**Seniors Housing, Uniting Kingscliff
Response to Request for Further Information**

This letter is prepared by Planit Consulting Pty Ltd (Planit) on behalf of the Proponent, The Uniting Church in Australia Property Trust (NSW) for Uniting (NSW.ACT) in response to the matters raised in the correspondence received from the Department of Planning, Housing and Infrastructure (the Department) dated 28 March 2025.

Table 1: Department of Planning, Housing and Infrastructure

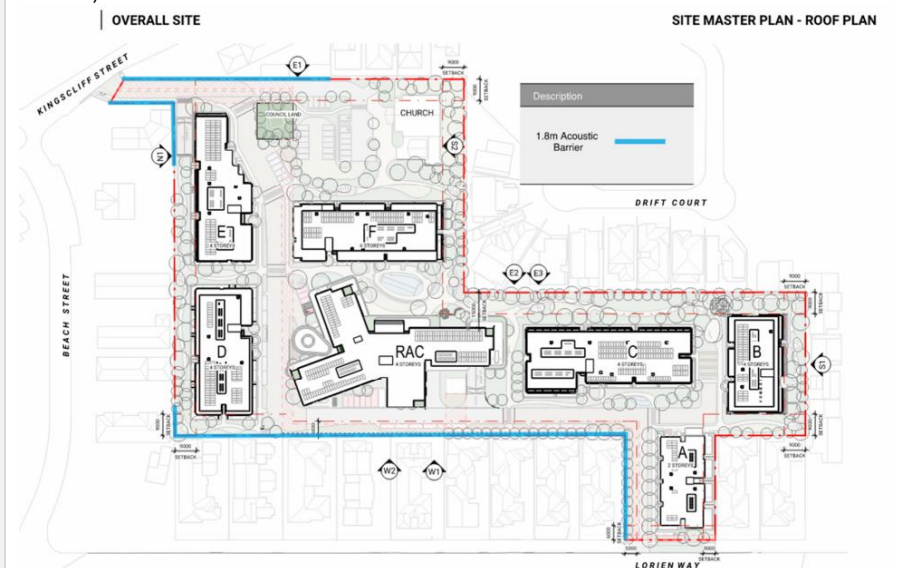
- The key habitat requirement for the Bush Stone-curlew as identified in the BAM-C, i.e., fallen/standing dead timber including logs; is not present on the subject land. Considering the absence of the species on the subject land at the time of surveys undertaken, the question as to whether the requirement to offset the species under the BOS is appropriate.

- Nevertheless, when considering the historical records on the subject land as notified by Council, and the known local population and

potential for future occurrence of the Bush Stone-curlew on the subject land, it is considered acceptable to adopt the requirement for offsets to be calculated by the BAM-C for the species. The BDAR (V3) has been updated to include the calculation of the credit offset requirement (9 species credits) for the Bush Stone-curlew on the subject land as well as being accompanied by a Bush Stone-curlew Management Plan
TSC-5b Prepare a Bush Stone-curlew Management Plan detailing suitable best practice construction phase avoidance and mitigation measures having regard for the Recovery Plan for the Bush Stone-curlew (<i>Burhinus grallarius</i>) dated February 2006 prepared by NSW DEC to include (but may not be limited to): - Pre-construction works survey undertaken by a suitably qualified ecologist. - Site personnel awareness induction. - Fencing and signage details. - Site monitoring by a suitably qualified ecologist during the construction period. - Protocol that specifies where roosting or nesting of Bush Stone-curlew is observed onsite immediately prior to or during construction, a construction exclusion zone of at least 30 metres radius is to be established around the nest or roost site. In the case of nesting birds all works are to cease in the exclusion area until chicks have fledged. In the case of roosting bird/s, all works must cease in the exclusion area until the roosting bird/s move offsite at their own volition. - Other contingency protocols (unintentional harm), contacts and details of any necessary animal ethics and/or handling licences or permits that may be required/obtained in the event of unintentional Bush Stone-curlew harm/injury or intervention actions.	Biodiversity Assessments and Solutions has prepared a Bush Stone-curlew Management Plan addressing all matters requested by Council, including best practice avoidance and mitigation measures consistent with the <i>Recovery Plan for the Bush Stone-curlew (Burhinus grallarius)</i> (NSW DEC, February 2006). This plan includes protocols for pre-construction surveys, site inductions, fencing and signage, ecological monitoring, exclusion zones, and contingency procedures in the event of harm or disturbance. The Management Plan is enclosed in Attachment L.
